## SERVICE BULLETIN

ENGINE - FUEL AND CONTROL - TO PROVIDE A NEW ELECTRONIC ENGINE CONTROL (EEC) WITH THE D5 SCN12 SOFTWARE CONFIGURATION - HAMILTON STANDARD SB EEC-150-20-73-15 - CATEGORY CODE 4 - MOD.ENG-73-0100

# V2500-ENG-73-0100

Location of the Electronic Engine Control (EEC)  
Fig.1

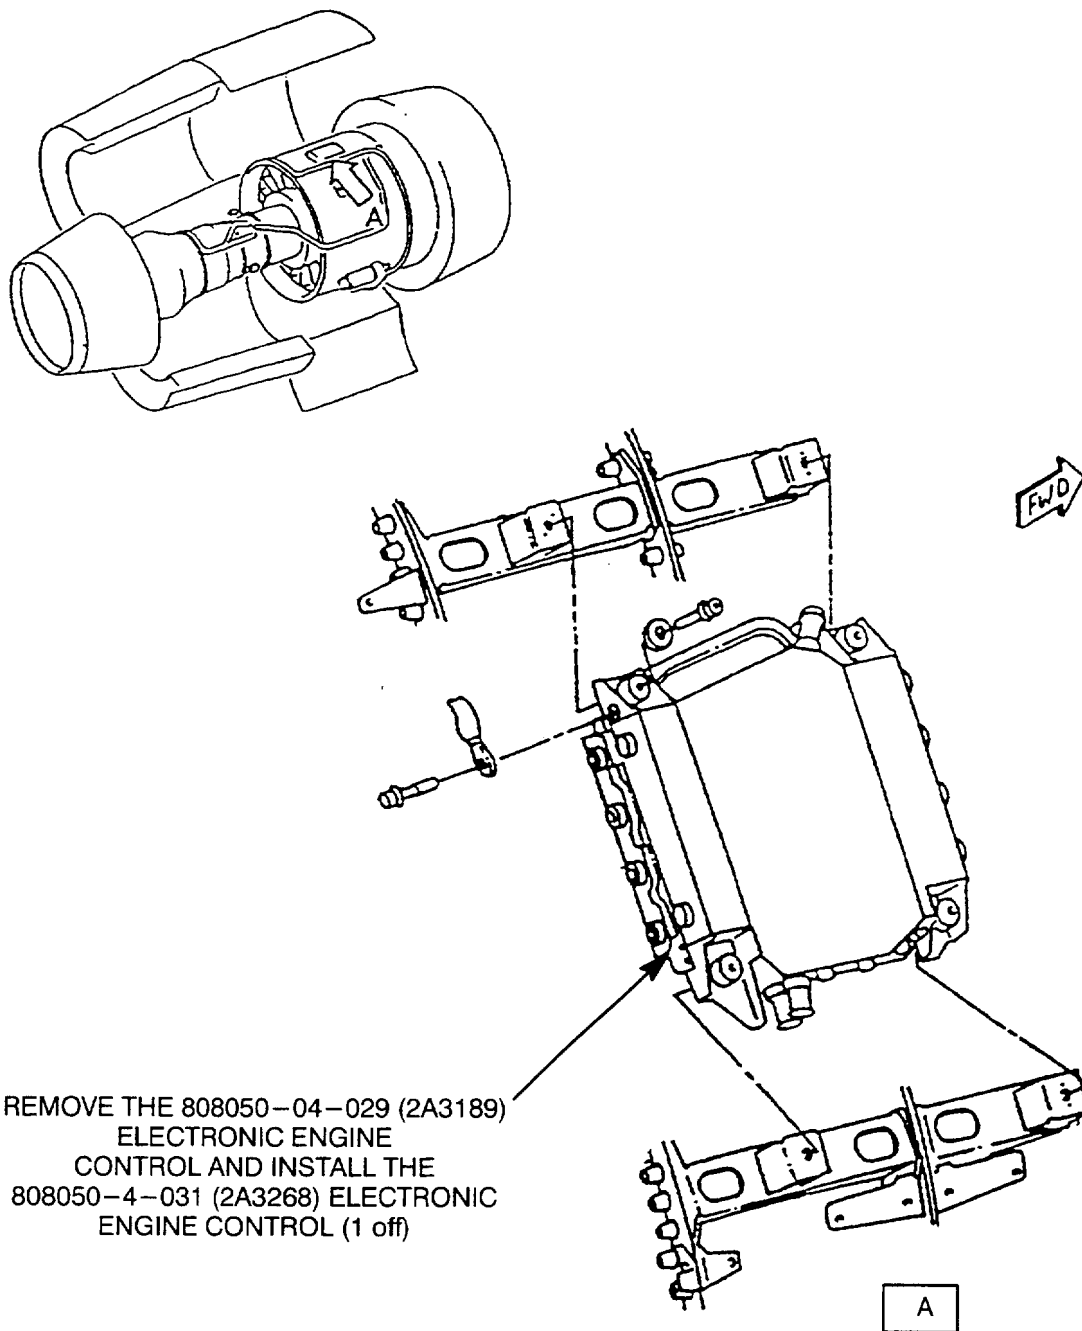
- (1) Remove the 808050-4-029 (2A3189) Electronic Engine Control by the procedure given in Reference (3), Chapter/Section 73-21-34, Removal Installation. Refer to Figure 1.

- (1) Install the 808050-4-031 (2A3268), Electronic Engine Control (1 off) by the approved procedure given in Reference (3), Chapter/Section 73-21-34, Removal/Installation.

Family Tree - Electronic Engine Control (EEC) Ref. Catalog Sequence No. 73-22-34. Fig.  
01 Item 280  
Fig.2

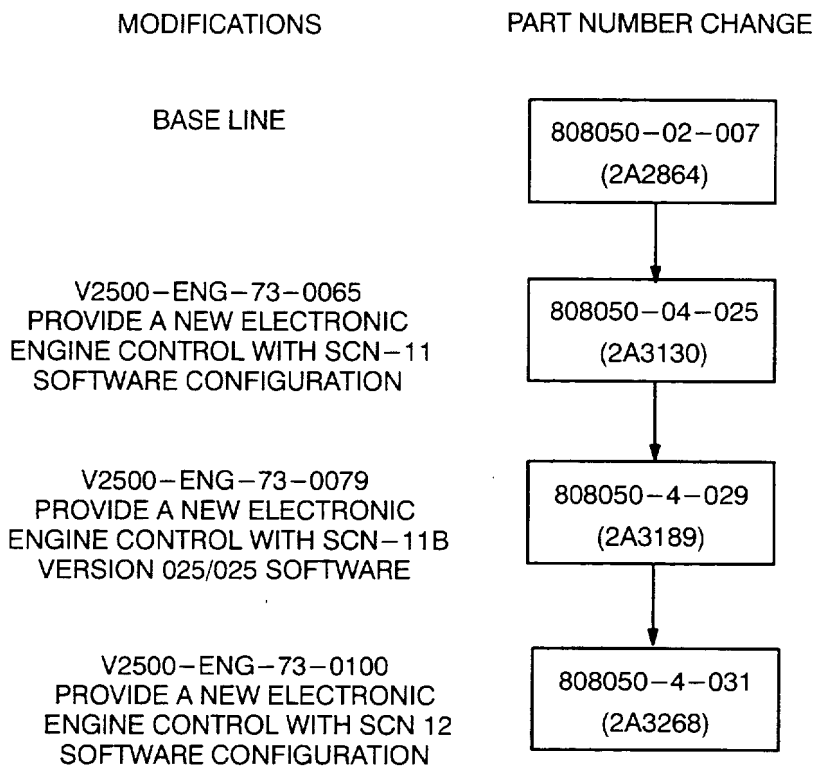
808050-4-031	1		Control,	808050-4-029	(1D)(A)
(2A3268)			Electronic	(2A3189)	
(73-21-34)			Engine	(01-280)

(1D) The new part can be obtained through modification by the approved procedure in Reference (2). Purchase the new parts from or return the old parts for modification to one of the approved vendors listed in Paragraph 2. B. in the Accomplishment Instructions.
